DOCKETED

Laurelwood Data Center (19-SPPE-01)

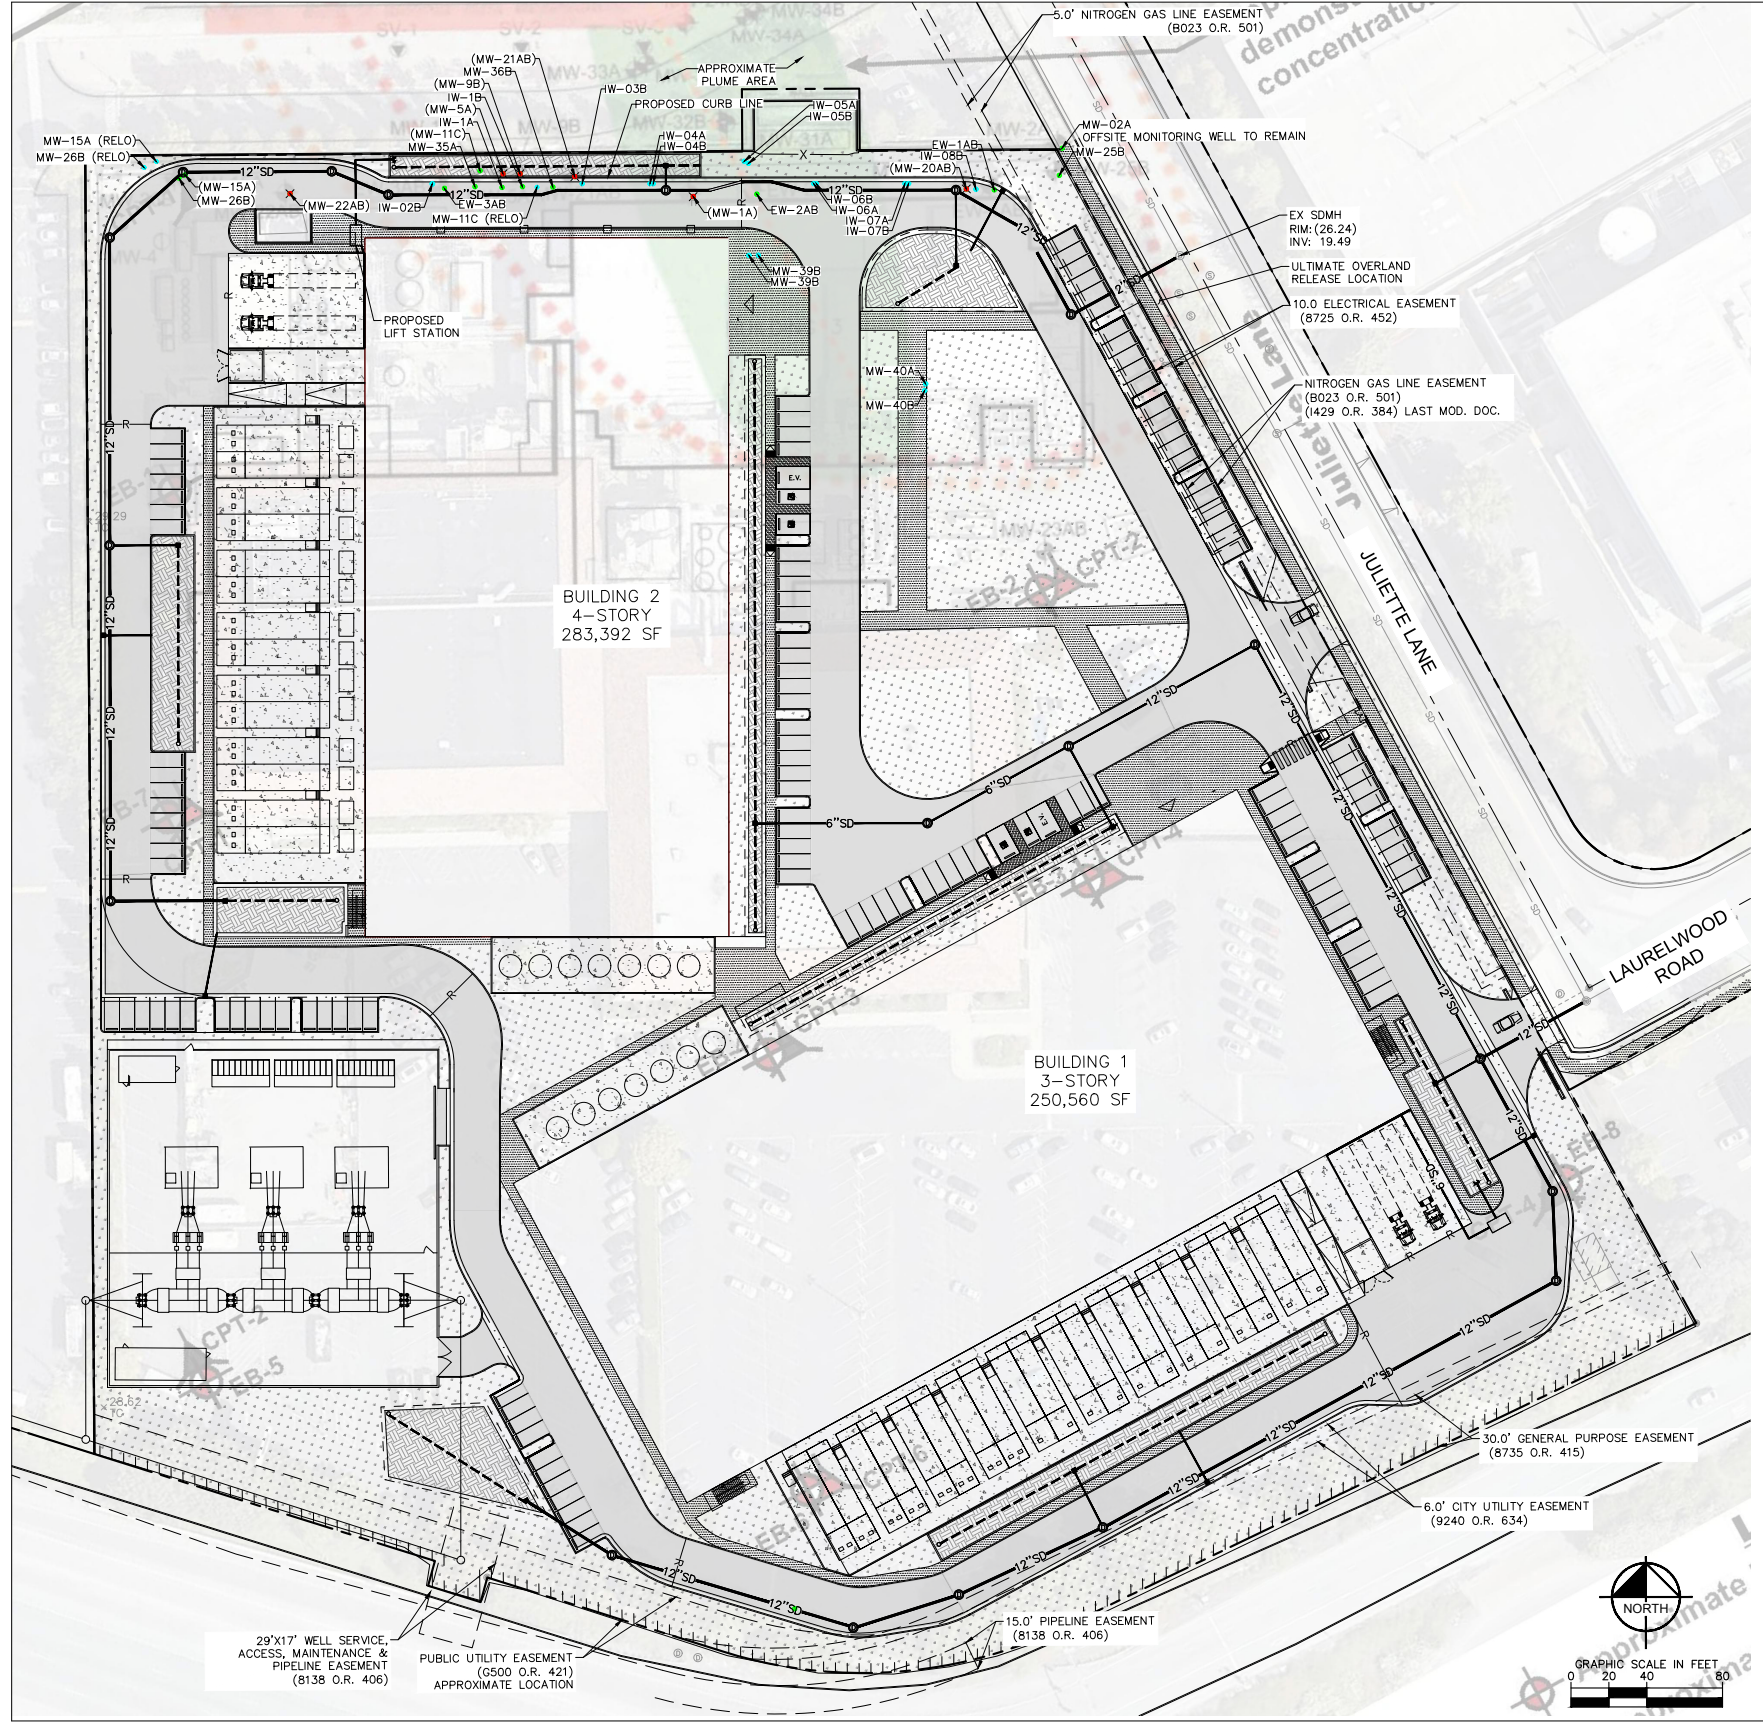
Response: Extracted groundwater resulting from dewatering activities would be treated and discharged under the existing VOC and Fuel General Permit for the site. Approval from the Regional Board would be required if significant modifications to the existing Authorization to Discharge associated with this general permit are required, though this is not expected. Potential modifications could include change in flow rate or treatment system design, if necessary. Regional Board review and approval would be required if dewatering activities are anticipated to adversely impact ongoing remediation activities. The Regional Board may require additional monitoring wells and/or sampling events to evaluate potential impacts. The ongoing groundwater cleanup will continue and will not influence the project schedule, given that the site is well-characterized, the treatment system will continue to operate, and the approved monitoring well system will ensure Regional Board’s continued oversight of ongoing cleanup activities.

Response: No other discharge permits are anticipated to be required.
